Commonwealth Edison

October 18, 1976

Subject: Dresden Station Units 2 and 3
Quad-Cities Station Units 1 and 2
Proposed Change to Technical Specifications
Appendix A to DPR-19, DPR-25, DPR-29, and
DPR-30 to Authorize Single Loop Operation
NRC Docket Nos. 50-237/249 and 50-254/265

FIGURE 4-1
 PEAK CLADDING TEMPERATURE FOLLOWING A DBA FROM SINGLE LOOP OPERATION FOR EXAMPLE PLANT

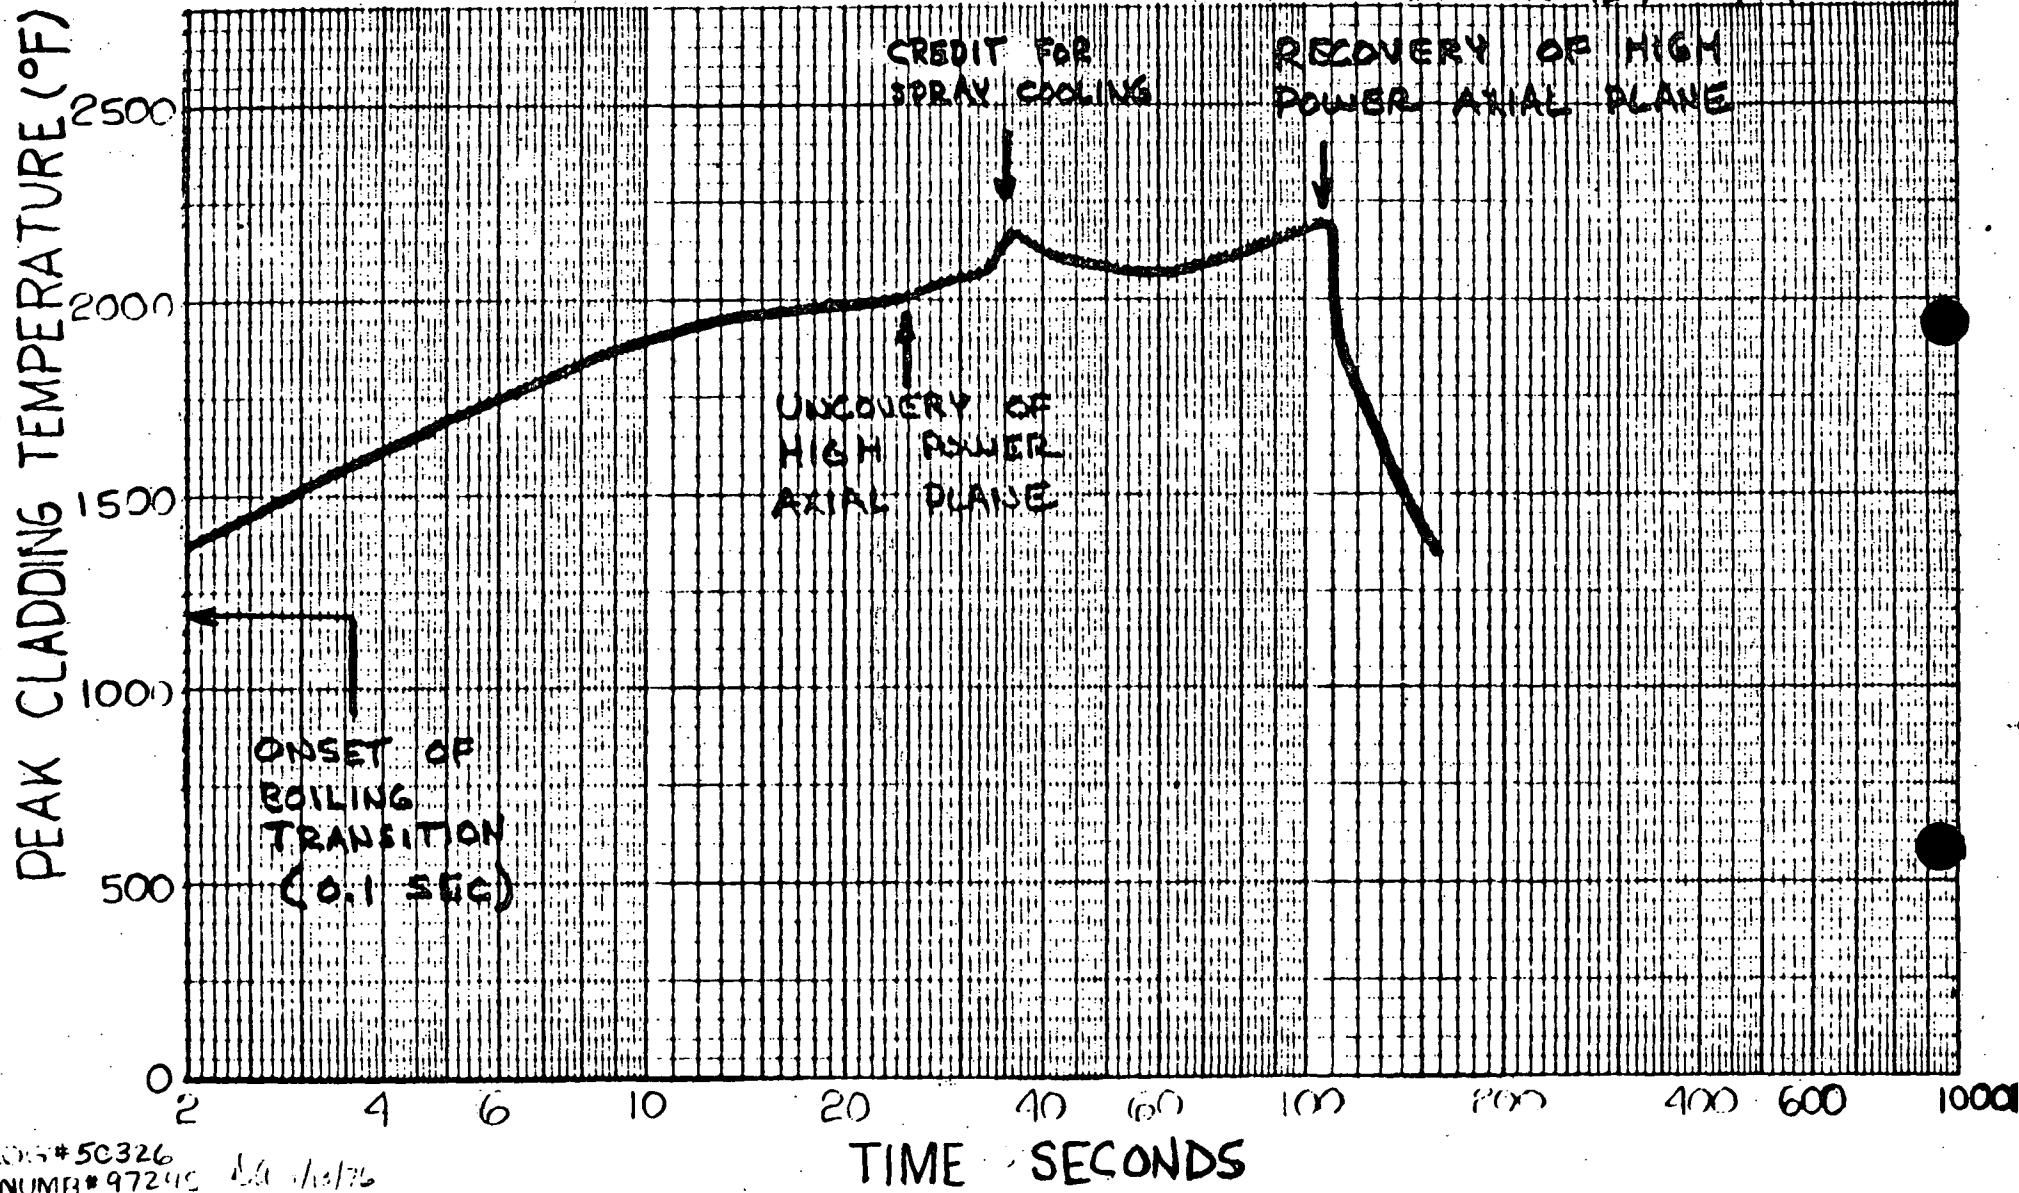
Please substitute corrected pages 91a and 99a in Enclosure (2) to Reference (a) and add Figures 4-1 and 4-2 to Enclosure (4) to Reference (a).

Enclosure (2): 60 Copies, Figures 4-1 and 4-2, Peak Cladding Temperature Following a DBA From Single Loop Operation for Example Plant.
